SUBJECT: 25-040 Loaf Land Subdivision - Comment Response

Thank you for your continued review of the Subdivision Application Permit (SP 4103) for Loaf Land Subdivision in Coplin Plt.. The team recently received the additional review comments from LUPC in regard to this application, dated August 27, 2026. These comments can be seen below in *italic*, followed by Main-Land's response in regular typeset. Updated or amended exhibits have been provided as attachments.

DRAWING NO.
C5.3

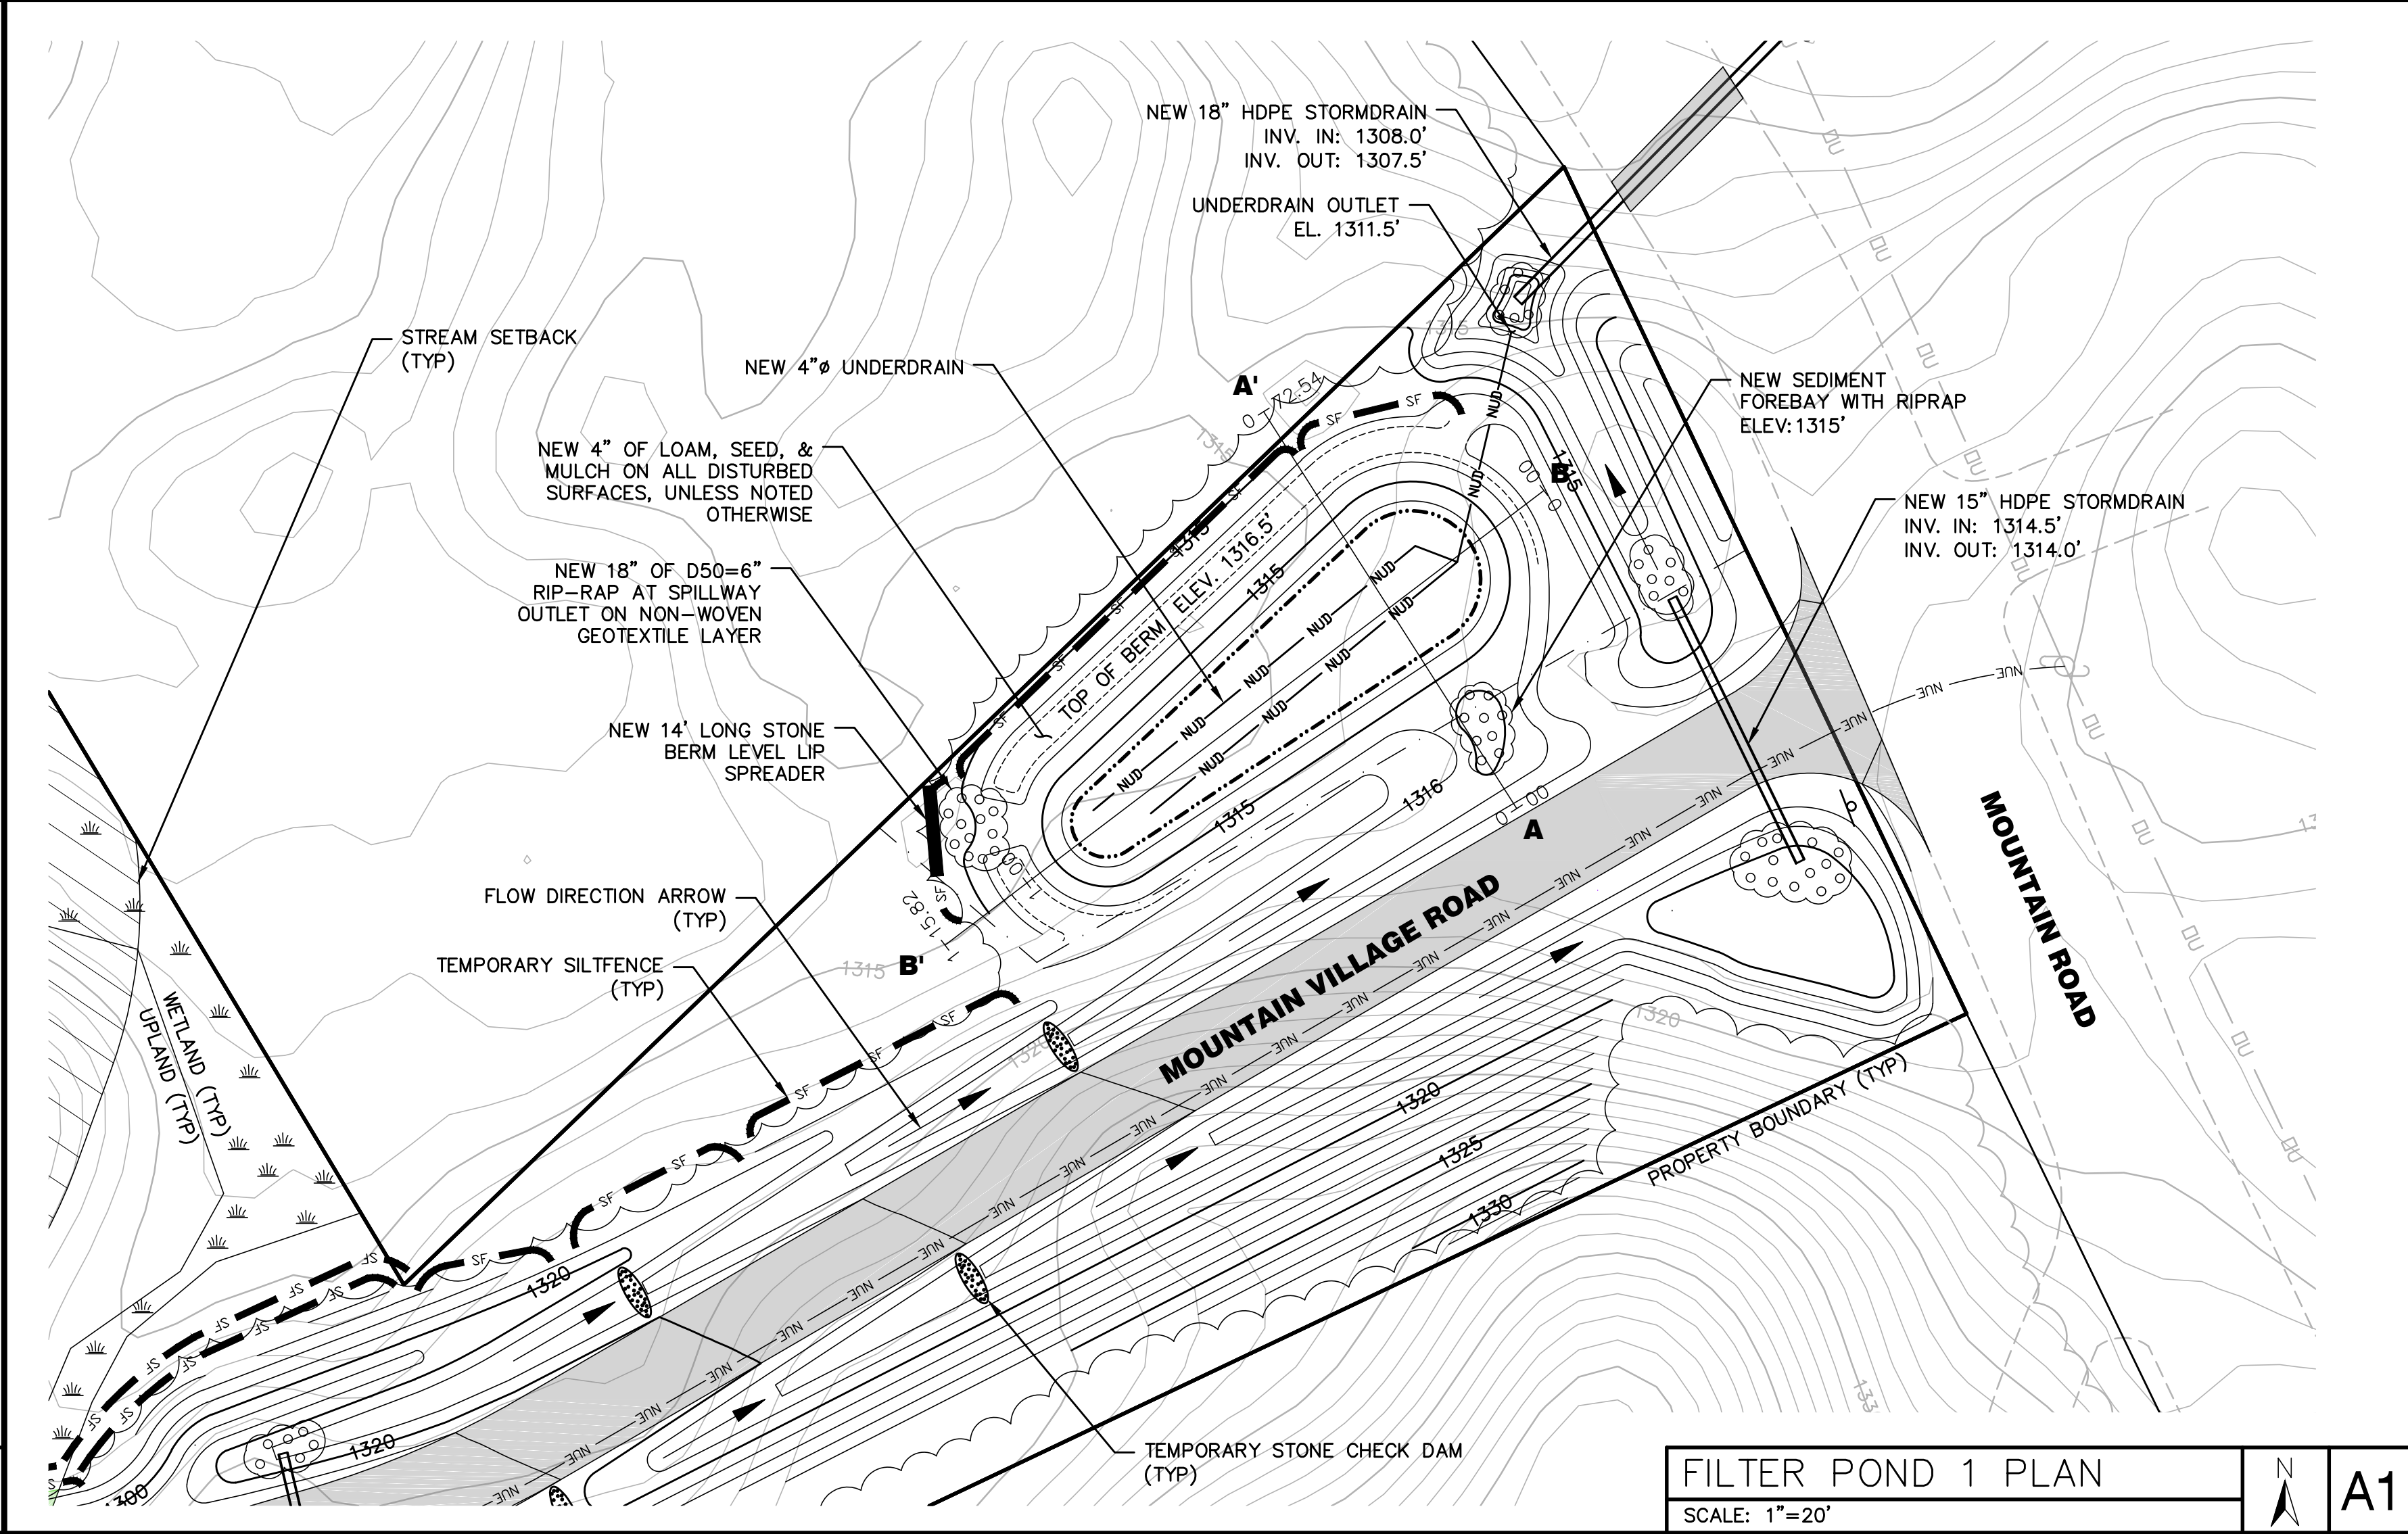
- *On Plan C5.3 (Stream Plan & Profile), clarify the design of the wingwall and how wetland impacts will be avoided during construction (see Sebago Technics review comment IV.11 on Sheet C5.3).*
 - *Sebago Response: The stream profile appears to indicate the need for a 7 foot-tall wing wall on the outlet side. The plans should better depict the design intent of this wingwall and how wetland impacts will be avoided during its construction. Silt fence is also shown through the wetland in this area with no stated wetland impact in this area. Additionally, the design plans include lengths of side slopes that are at 2H:1V or steeper. It should be shown on the grading plan which slope stabilizing measures are to be used and their extents where the side slope exceeds 3H:1V.*

The design plans have been updated accordingly. The wing wall design has been reduced to consist of a 4' wall, an acceptable height for a boulder wall installation by the contractor. The

siltfence and grading has been adjusted to provide more clearance adjacent to wetland. Lastly, the steeper sections have been indicated on C3.1 Grading Plan.
